**Appendix F –  
Drainage Impact Assessment**

**Proposed Amendments to an Approved Comprehensive Residential Development Scheme and Minor Relaxation of Gross Floor Area and Building Height Restrictions at Various Lots in D.D. 385 and Adjoining Government Land, Tai Lam Chung, Tuen Mun**

**Drainage Impact Assessment**

Report Reference: 240010.02

Figure 1: Existing Scenario at Wong Uk

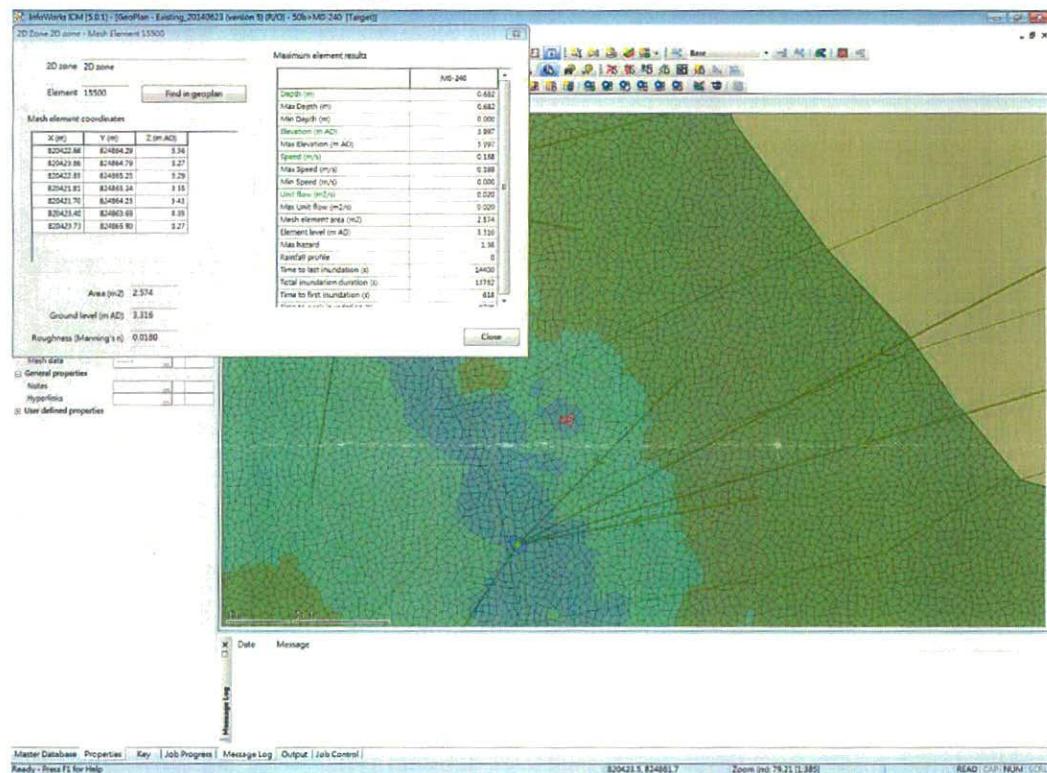
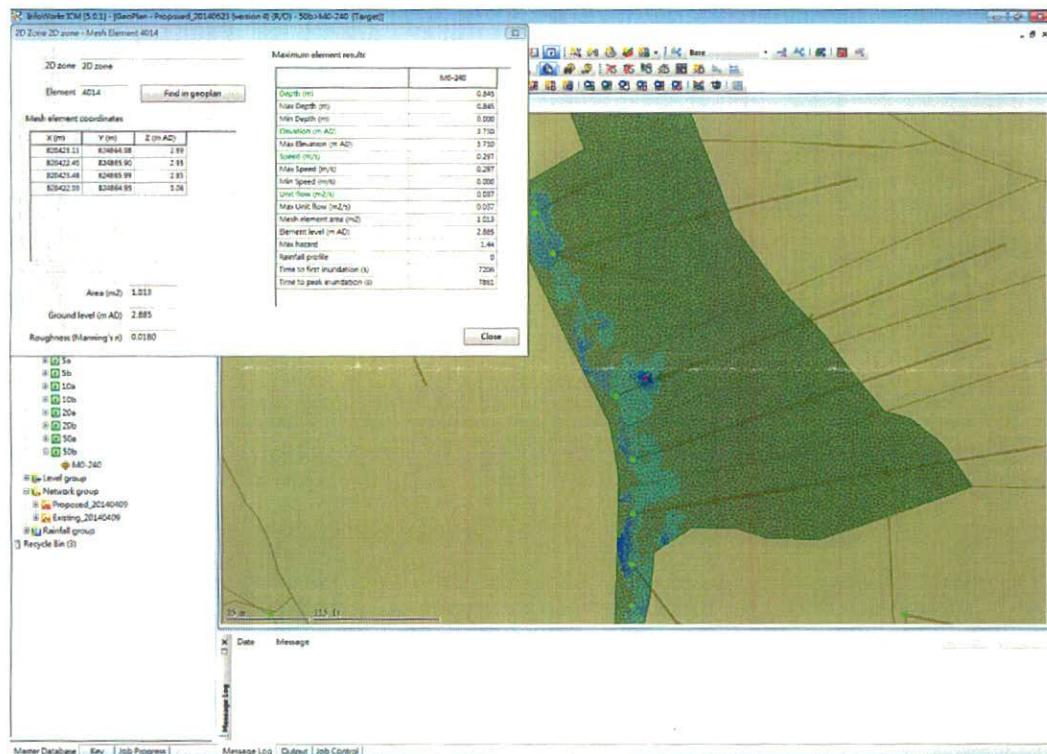
The flood depth at Wong Uk with coordinate (824864N, 820423E) in existing and proposed scenarios are 0.662m and 0.845m respectively. There is 0.183m increase of flood depth. This will aggravate drainage conditions. Please revise the scheme.

## Annex A

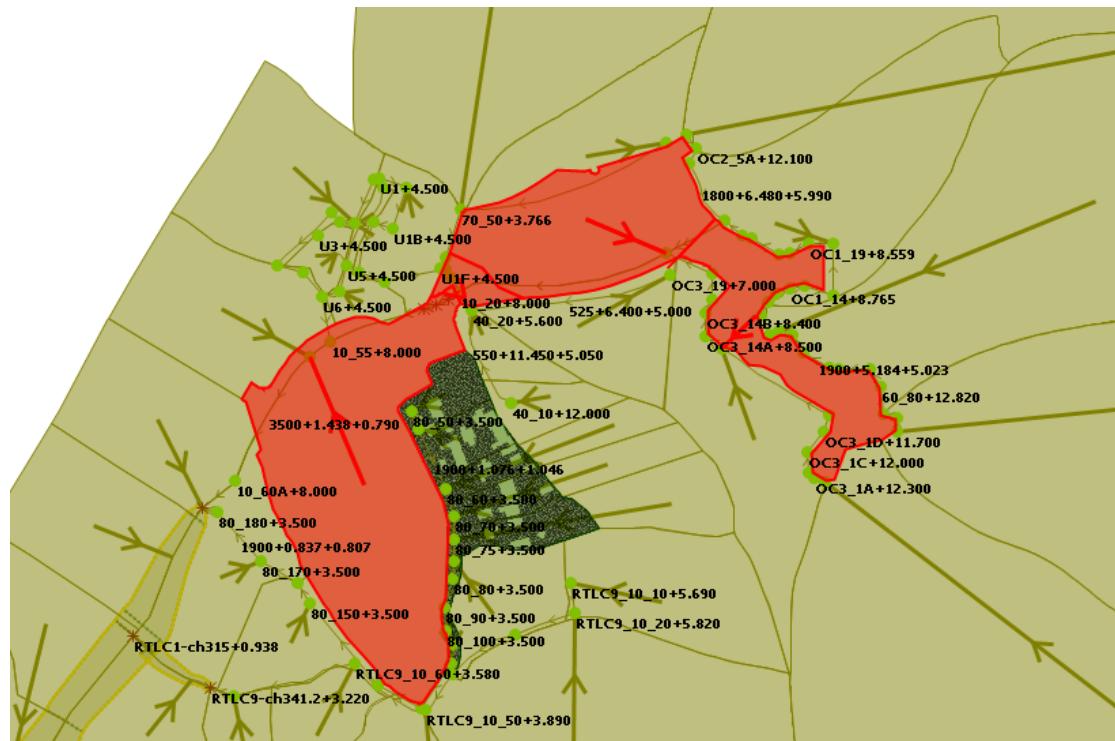
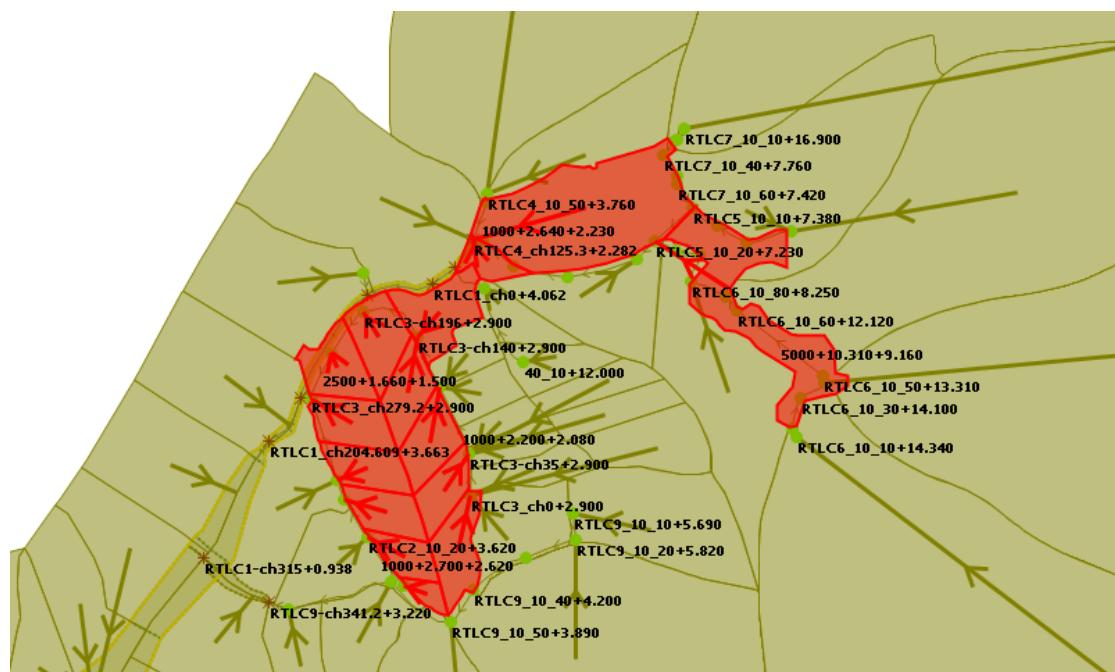
(4)		Please clarify the area and CN values in the Table 5.	Table 5 aims to explain the area CN value change due to the residential development. As shown in the Annex A with this responses to comments, in after development scenario, the catchments where residential development falls into have CN value of 87.5 based on 70% urban (CN95) and 30% greenery (CN70) assumption. As a comparison, in before development scenario, the area is storage, so a CN of 90 is assigned.

Residential Development Area = 4.604 ha. CN value for each sub-catchment is 87.5

Similar Area where residential development falls = 4.669 ha. CN value for each sub-catchment is 90

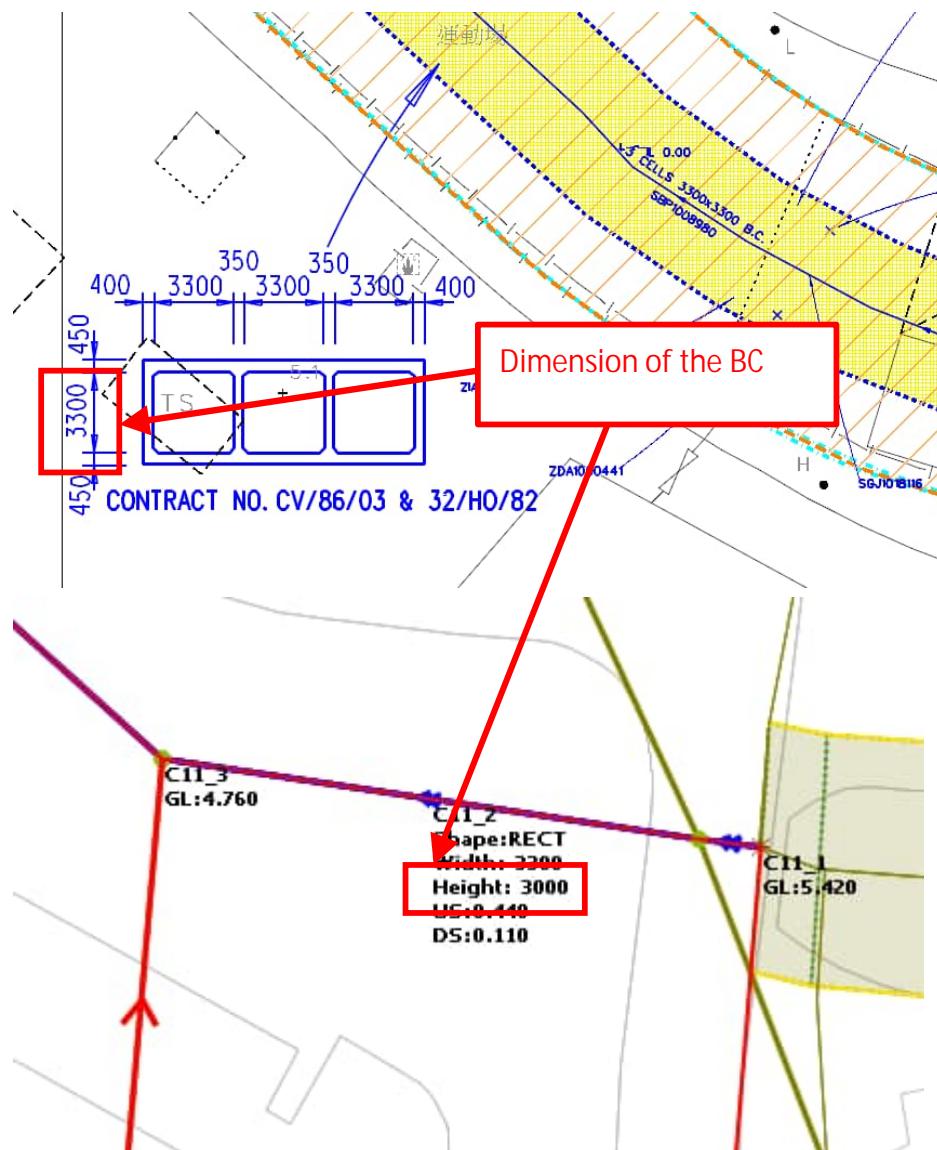
- Upstream flow of the Tai Lam Chung was ignored. Please review.

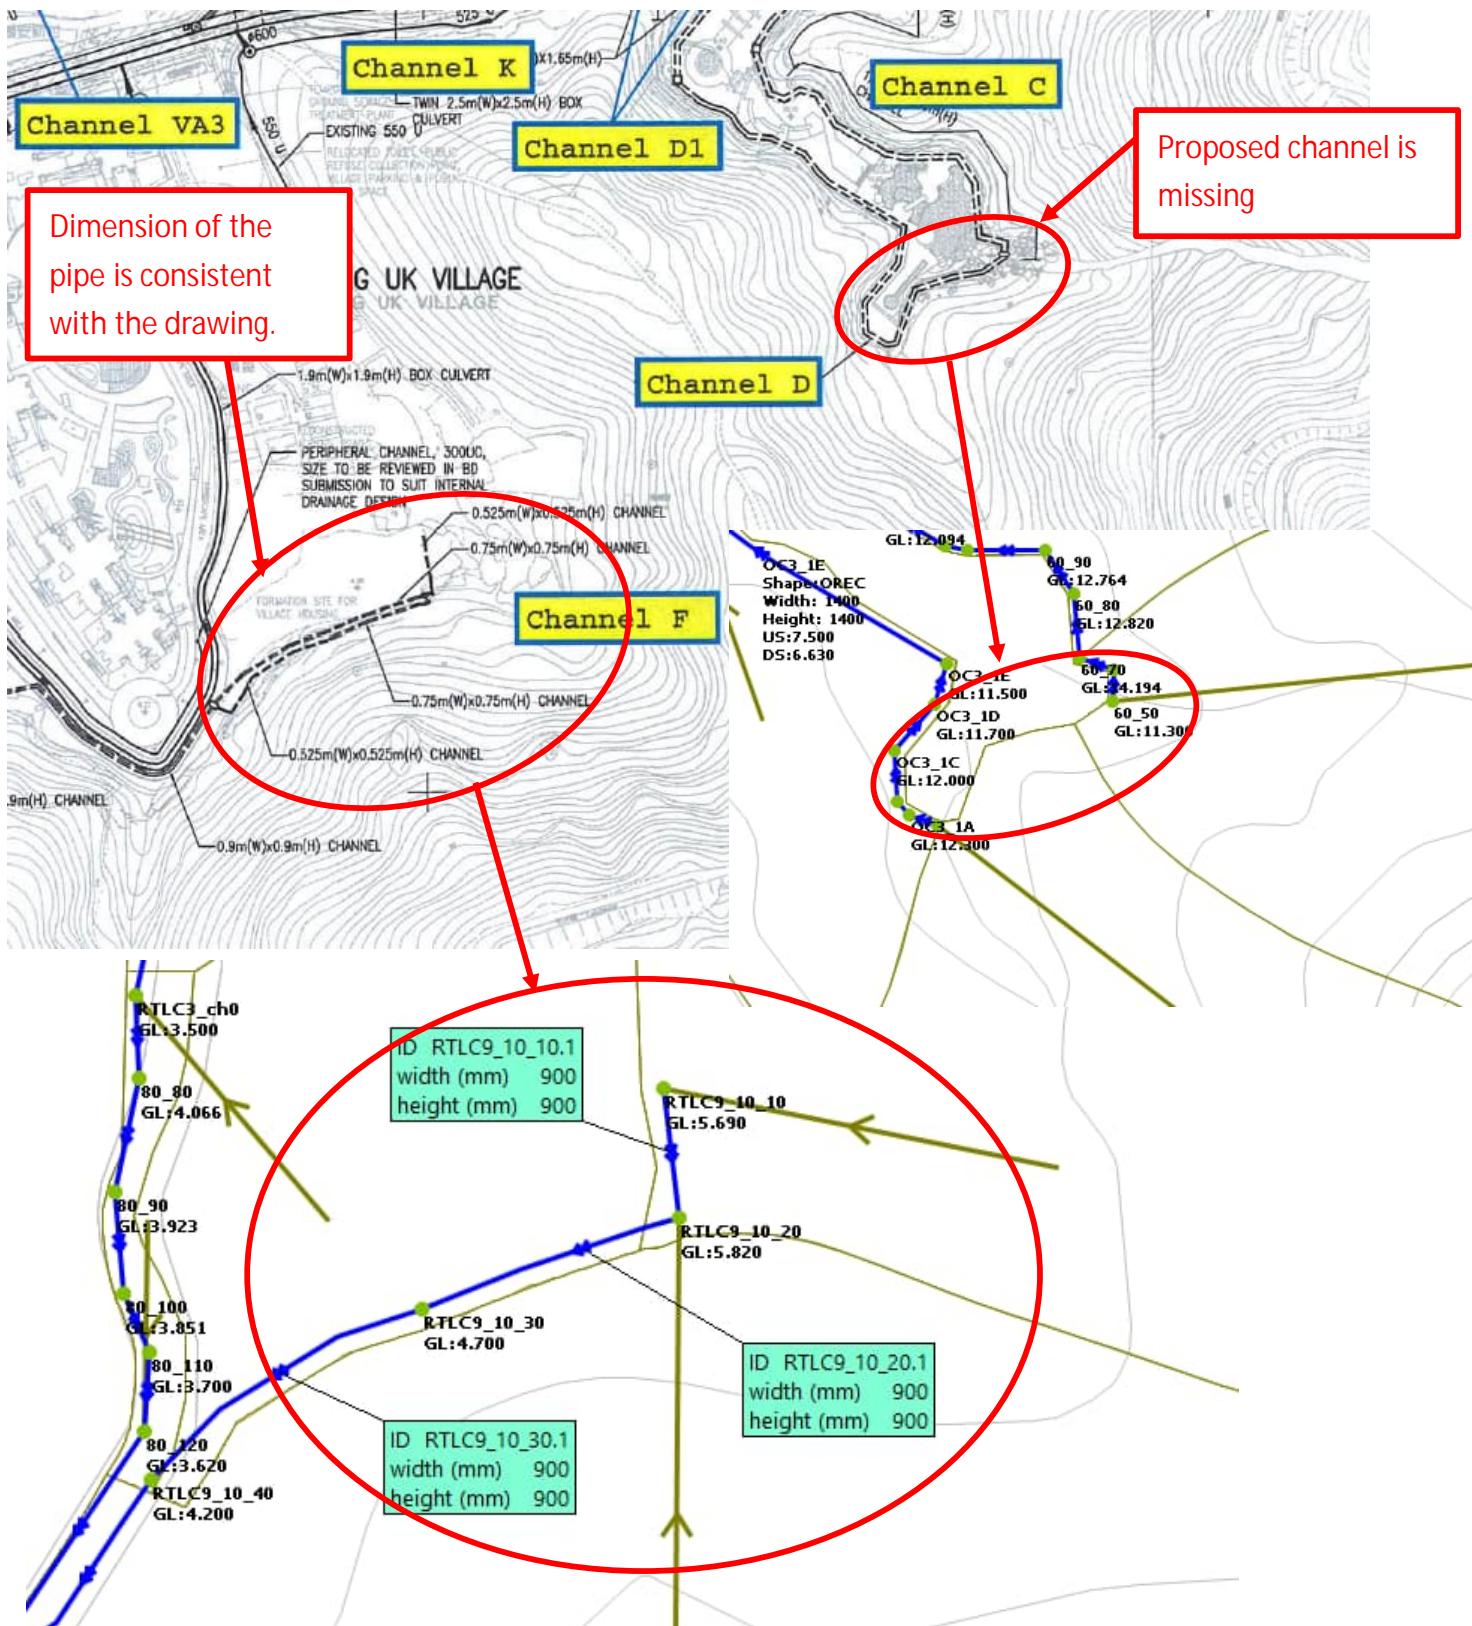
3. Value of catchment B2 and U1 in Table 1 are duplicated. Please clarify.

(3) Value of catchment B2 and U1 in Table 1 are duplicated. Please clarify	Table 1 is revised.
	(4) Drainage network is inconsistent with our drainage record and the drainage arrangement. Please review.	The hydraulic model is revised accordingly.

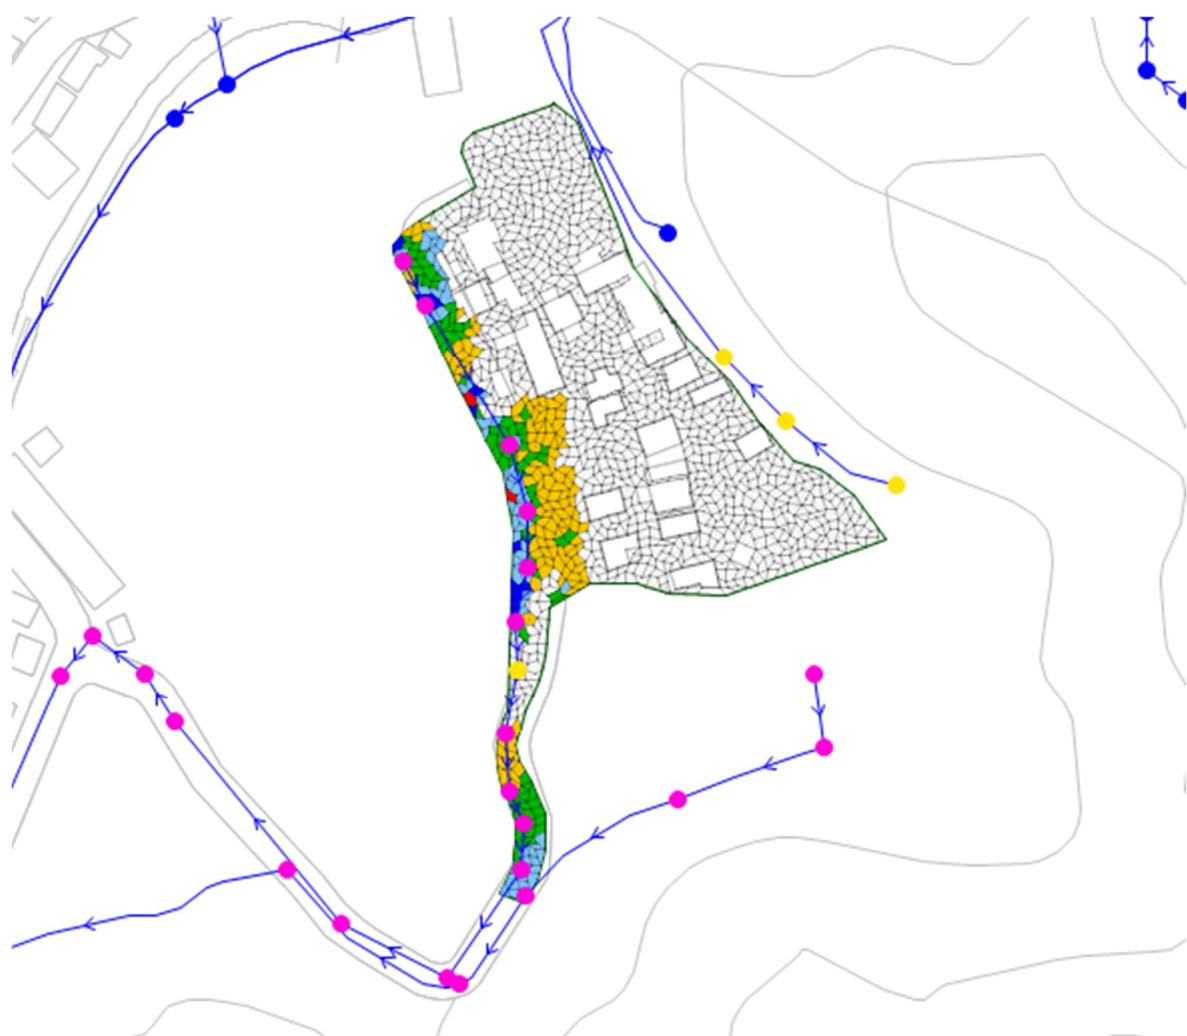
5. The area of 2D zone is very small in the model and flood depth on some nodes is more than 19m. It seems that the overland flow was not fully evaluated. Please review.
